Public Service Company of Colorado

November 30, 1983
Fort St. Vrain
Unit #1
P-83389

SUBJECT: LCO 4.1.9 Interim Measures

LC0 4.1.9-1

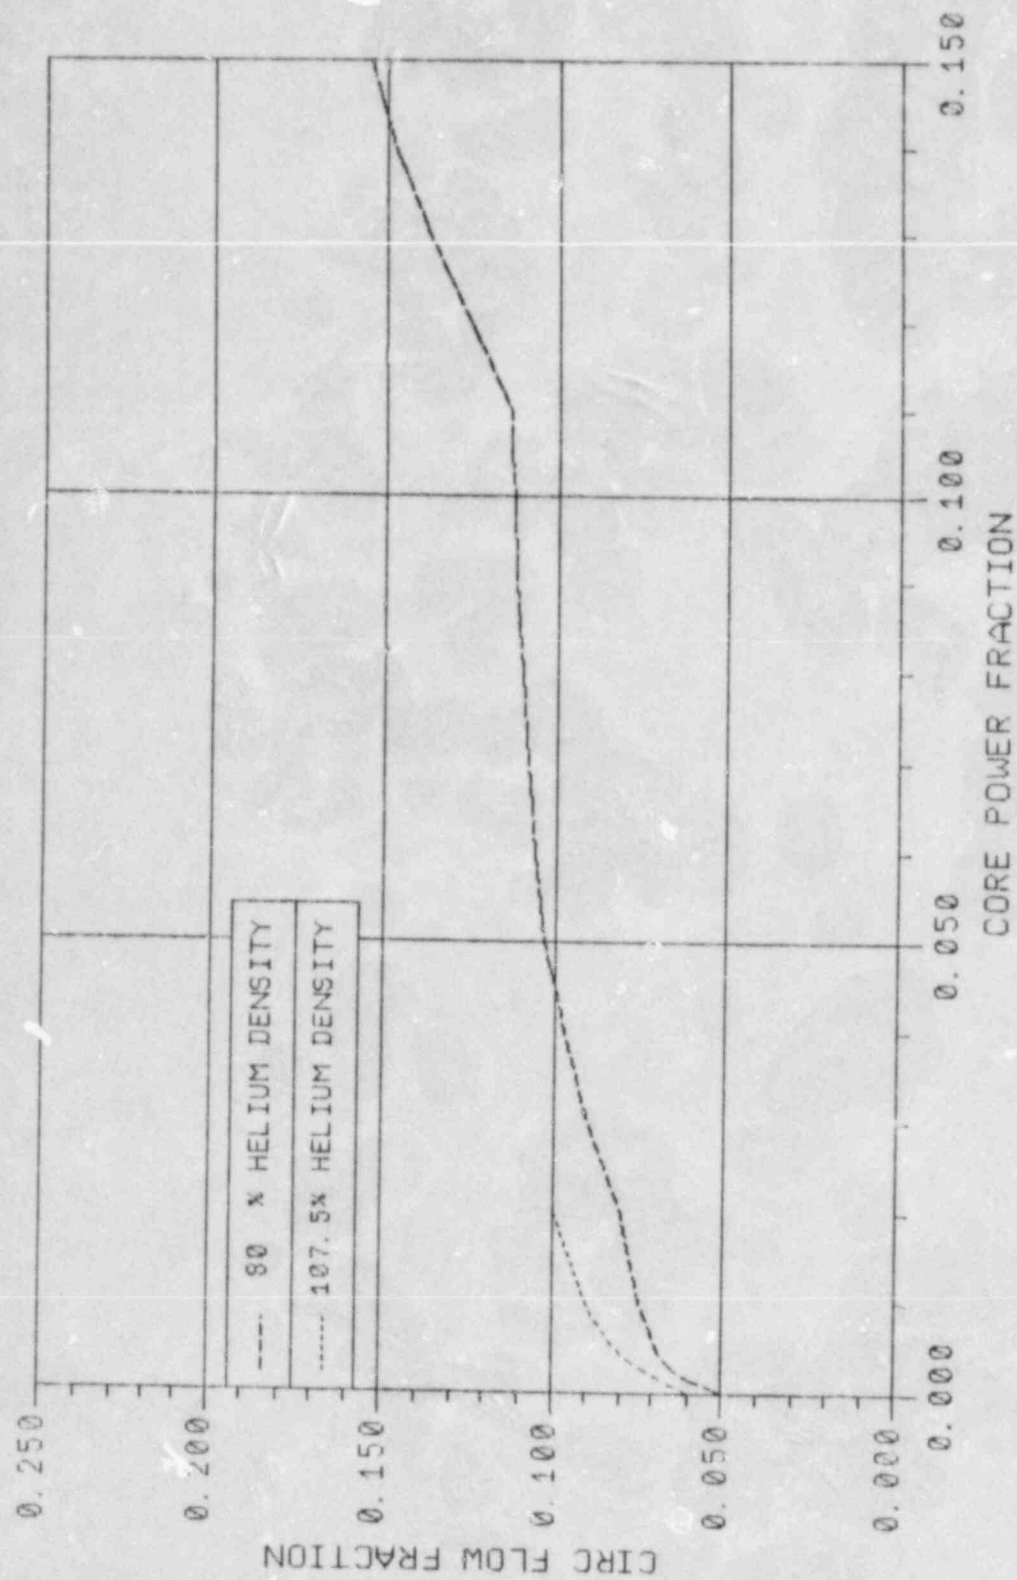
Attached is a copy of a figure to replace Attachment 1 of the referenced letter. This figure is a variation of the figure that Messrs. Fuller and Novachek provided you with when they were in Arlington on November 14, 1983. Those portions of the one provided to you that were less conservative than the existing Figure 4.1.9-1 have been deleted, but in all other regards, this figure is the same.

As stated to you and Mr. Ireland at the said meeting, Public Service Company of Colorado firmly commits to comply with the limits of this figure until such time as a formal Technical Specification change to LCO 4.1.9 can be issued, or more conservative measures are determined to be appropriate.
